660 University Avenue Mixed-Use Project

Final Environmental Impact Report/ Responses to Comments on the Draft EIR

SCH#2022110095

March 2025

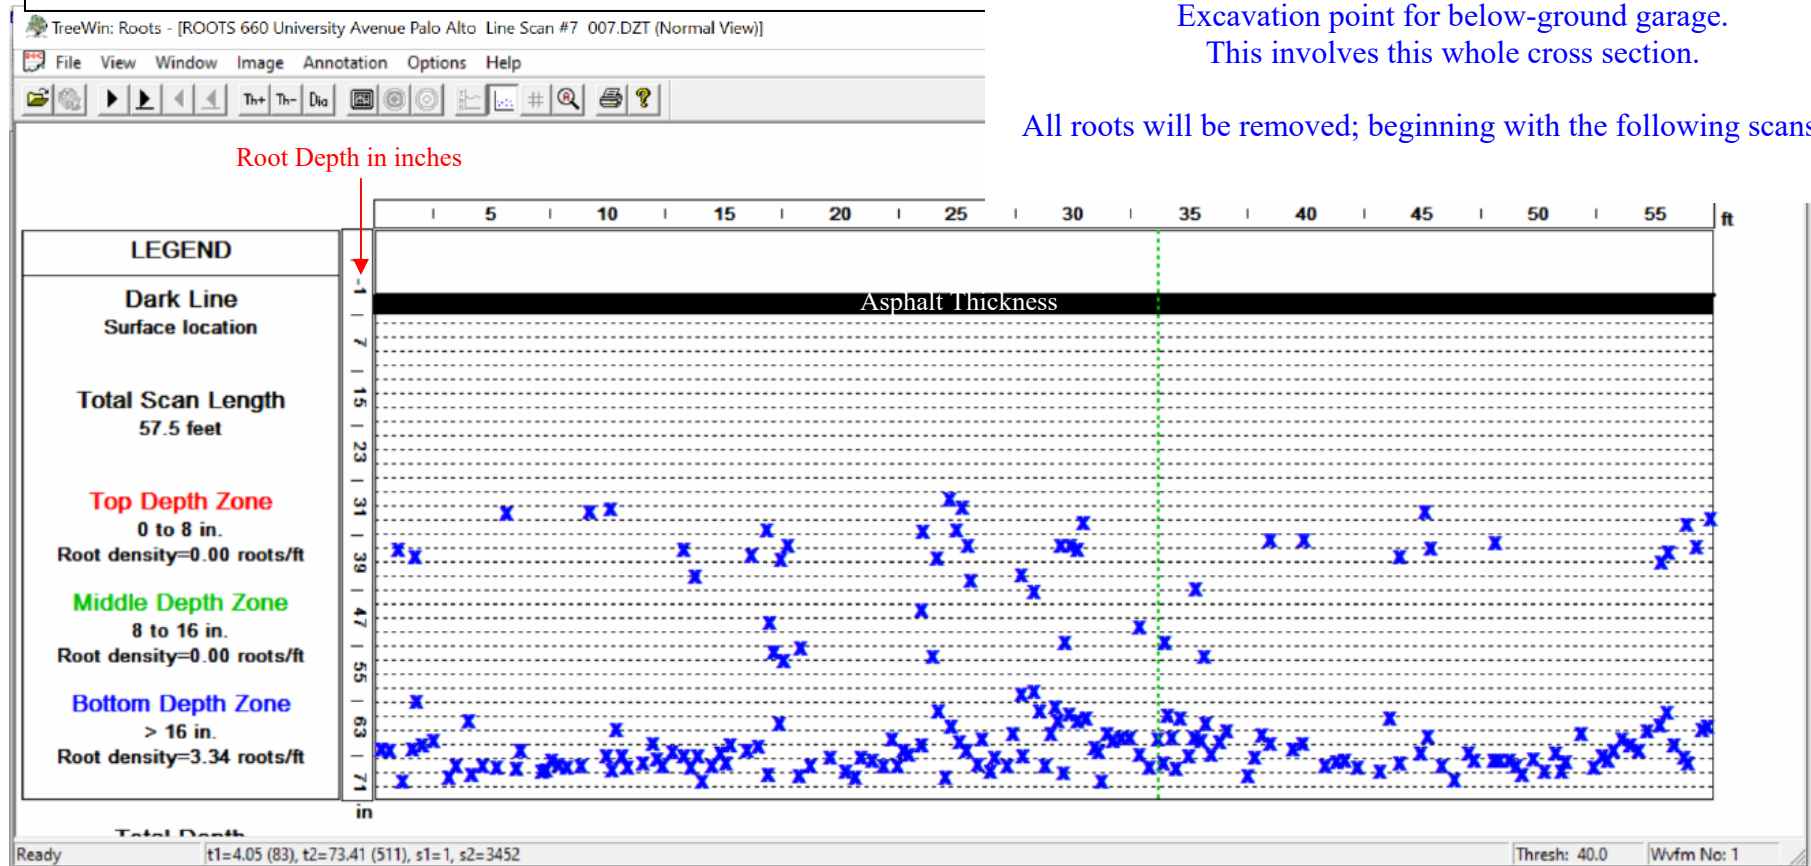
Excavation point for below-ground garage.
This involves this whole cross section.

All roots will be removed; beginning with the following scans 7-12

LANDSCAPE PLANS - DECK BENEATH TREE #10

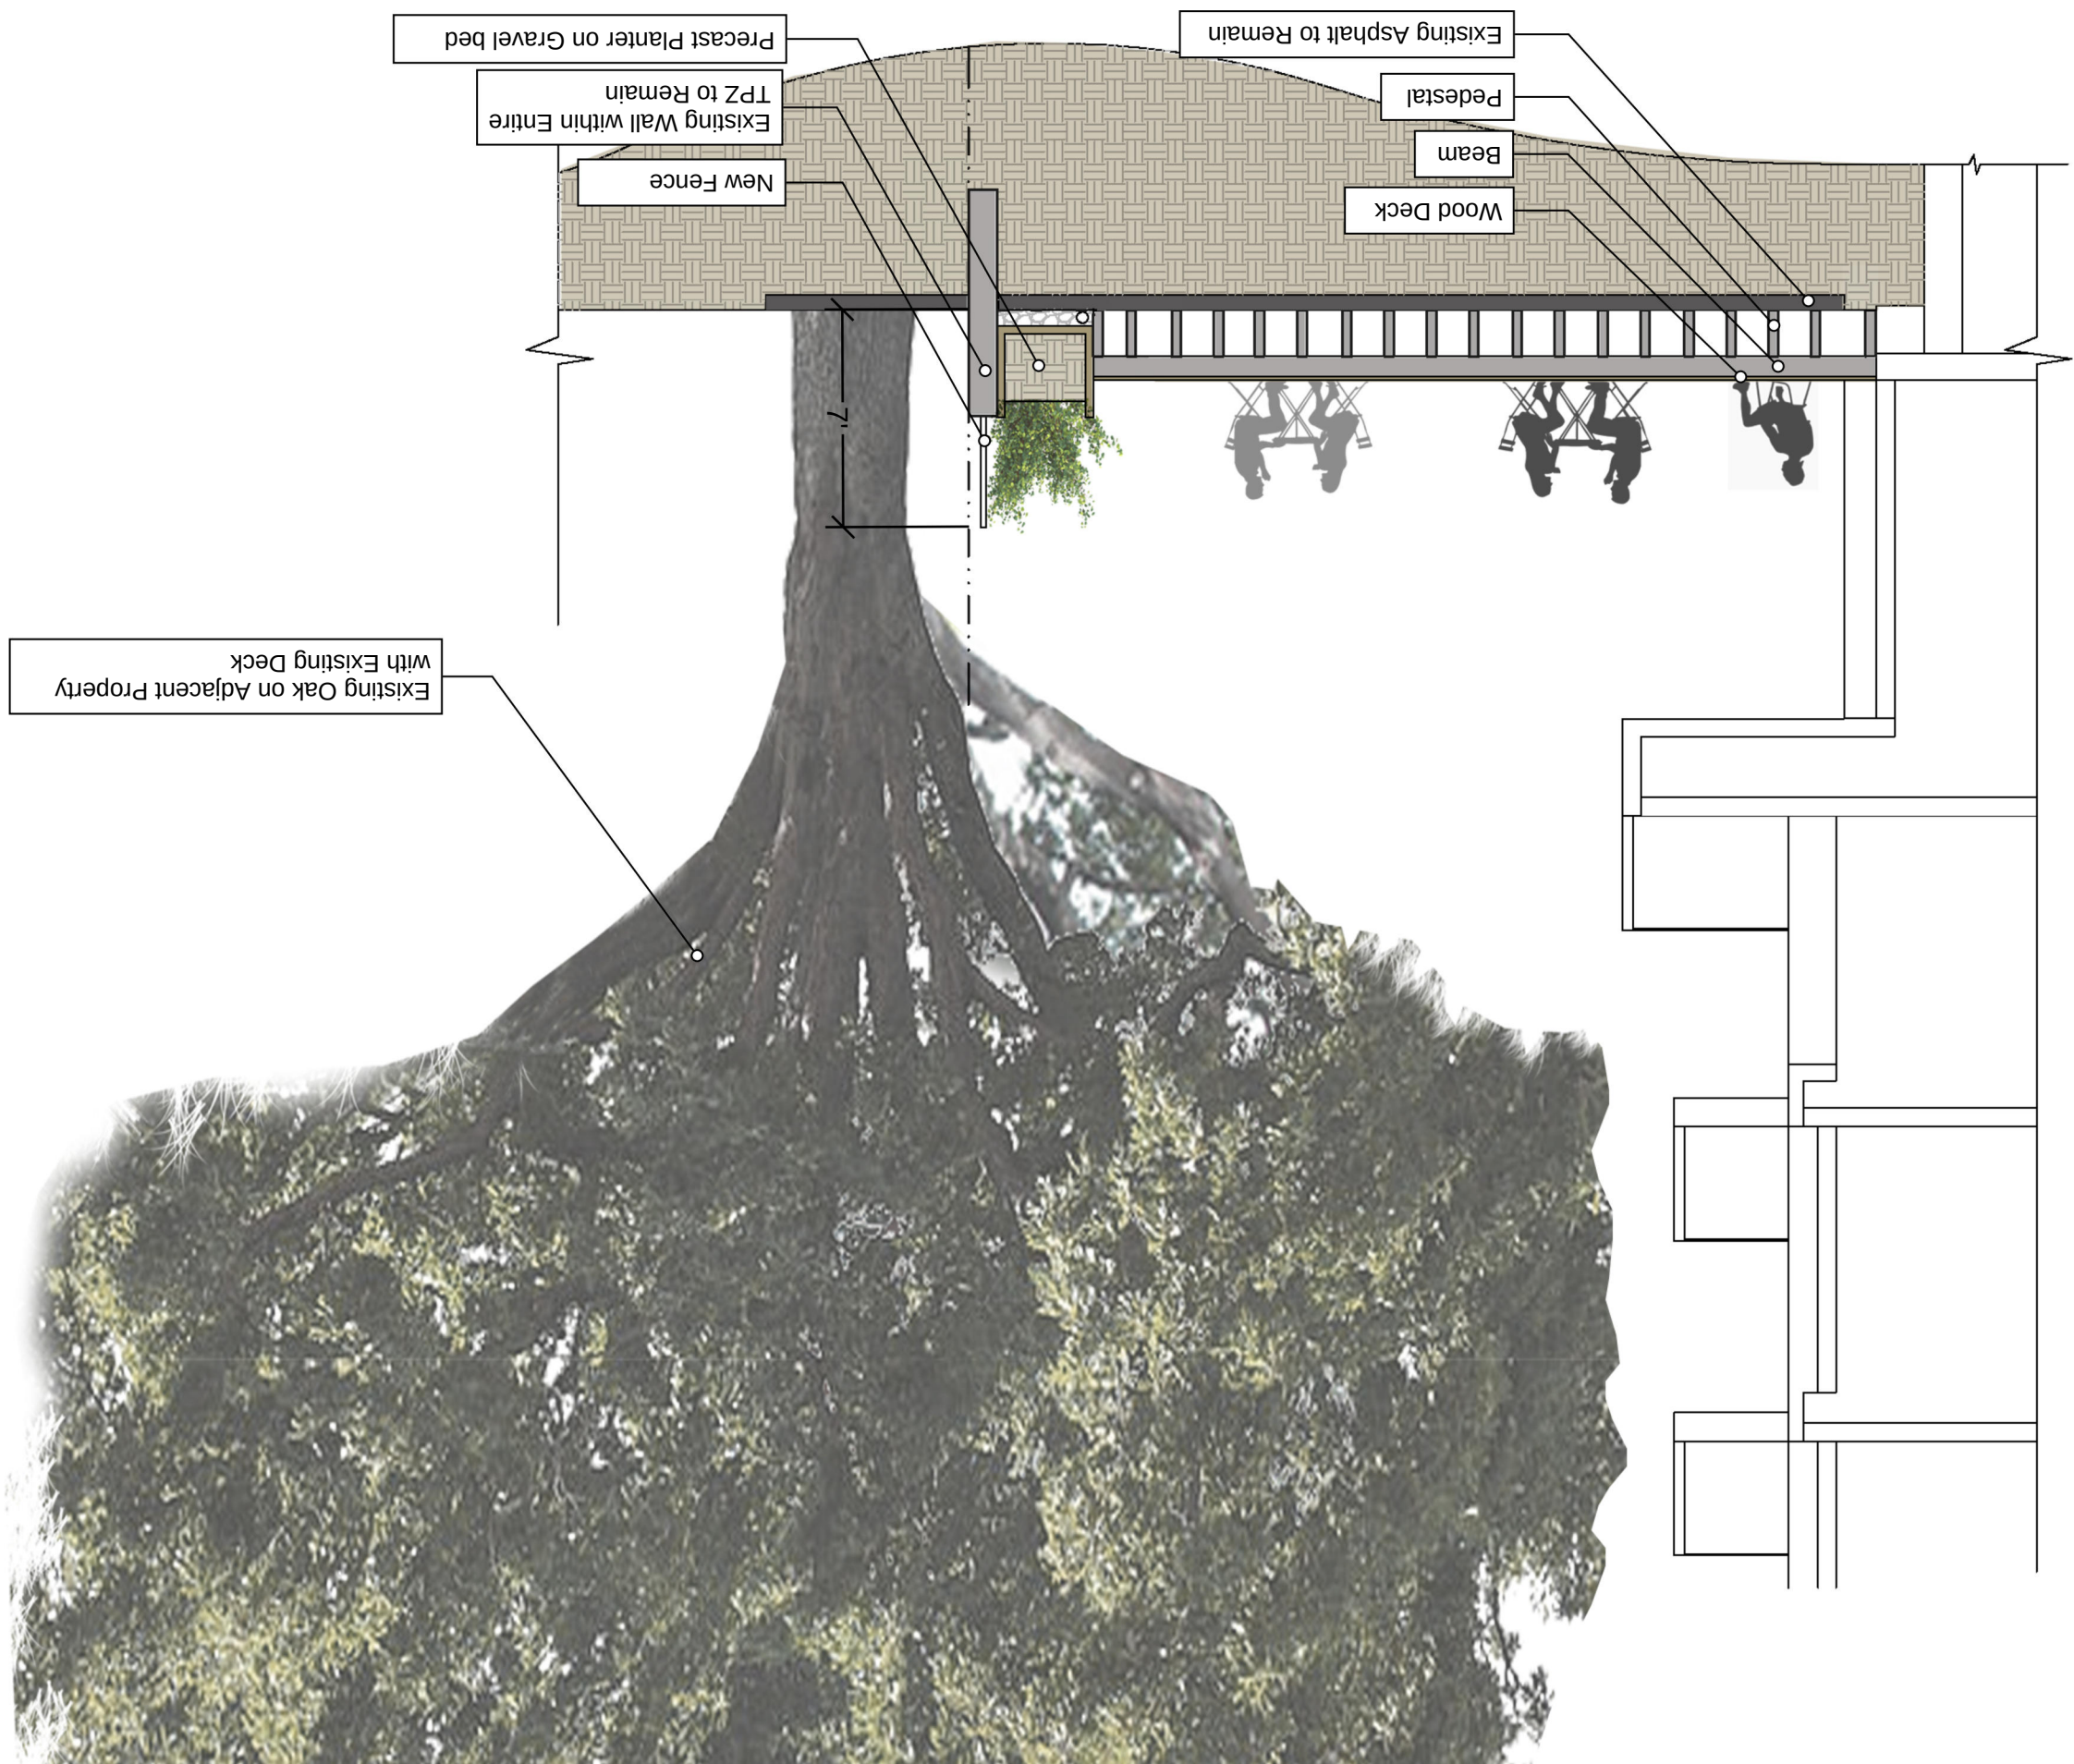
The 20-foot setback from #10's trunk for ground disturbance applies to any soil compaction, grading, subexcavation, overexcavation, trenching, drilling/auguring, storm drains, swales, etc. My review of proposed plans reveals this has been achieved, and a large section of existing asphalt within this area will be retained, a wood deck built on top, and section of existing retaining wall within the TPZ kept in place. Exhibit D includes both Sheet L1.1 and a detailed section of the proposed deck.

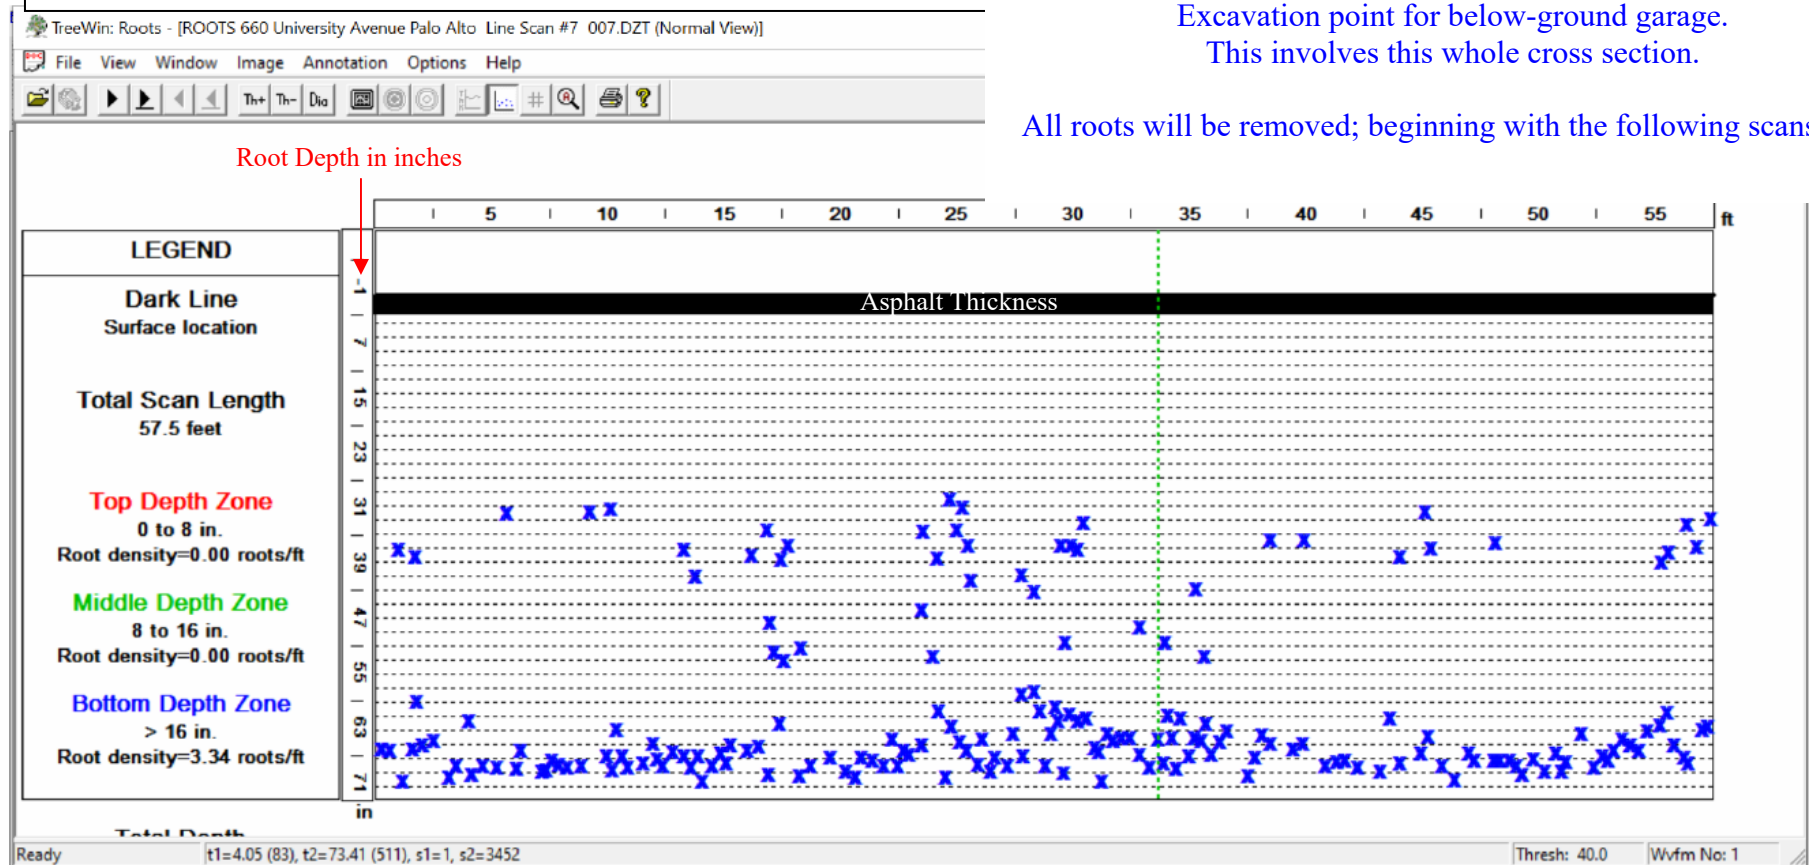
Excavation point for below-ground garage.
This involves this whole cross section.

All roots will be removed; beginning with the following scans 7-12
